Access Compliance Report

Public Rights-of-Way

(Curb Ramps)

Intersection ID: 28350	Main Street: REA_RD	Cross Street: LINDAHI_LN	Location: SW
ADA ID: F8DAF5B3A519	Ramp Type: PerpDiag	Initial Pass/Fail: Fail	Overall Compliance: No
Severity Score: 12.5			
Codes/Mitigation Info/Possible Solution		Field Measurements/Component Compliance

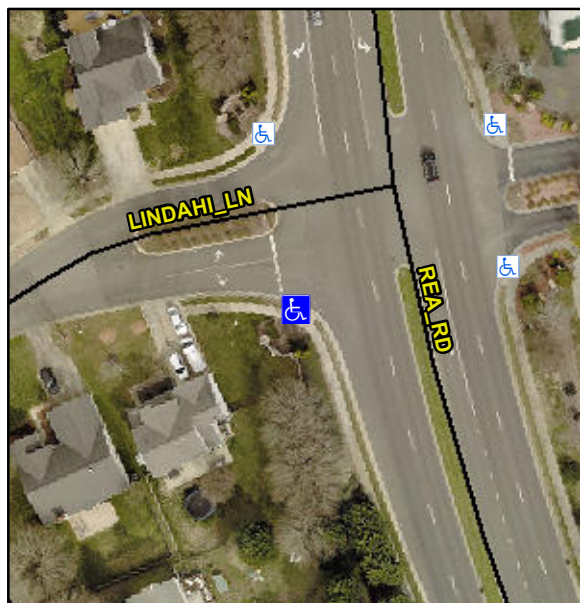
Not Found, R304.2.2

Compliance	Description	Data	Compliance	Description	Data
N/A	Ramp Length (in)	41.0	No	Ramp Slope (%)	8.9
Yes	Ramp Width (in)	62.0	Yes	Ramp XSlope (%)	0.5
N/A	Flare Type LT	N/A	N/A	Flare Type RT	N/A
N/A	Flare Slope LT (%)	N/A	N/A	Flare Slope RT (%)	N/A
N/A	Flare Traversable LT?	N/A	N/A	Flare Traversable RT?	N/A
N/A	Landing Length (in)	N/A	N/A	DWS Provided?	N/A
N/A	Landing Width (in)	N/A	N/A	DWS Contrast?	N/A
N/A	Landing Slope (%)	N/A	N/A	DWS Length (in)	N/A
N/A	Landing X Slope (%)	N/A	N/A	DWS Full Width?	N/A
N/A	Landing Curb? (Y/N)	N/A	N/A	DWS Offset (in)	N/A
N/A	Shared Landing?	N/A			
N/A	Gutter Ponding?	N/A	N/A	Gutter Slope (%)	N/A
N/A	Gutter Lip Ht (in)	N/A	N/A	Gutter X Slope (%)	N/A
N/A	Painted X Walk1?	No	N/A	Painted X Walk2?	No
	X Walk 1 Direction	To E		X Walk 2 Direction	To N
N/A	X Walk 1 Width (in)	N/A	N/A	X Walk 2 Width (in)	N/A
	X Walk 1 Slope (%)	4.0		X Walk 2 Slope (%)	1.0
	X Walk 1 X Slope (%)	0.9		X Walk 2 X Slope (%)	3.1

Remove & Replace Curb Ramp With Two New Directional Ramps or Equivalent.
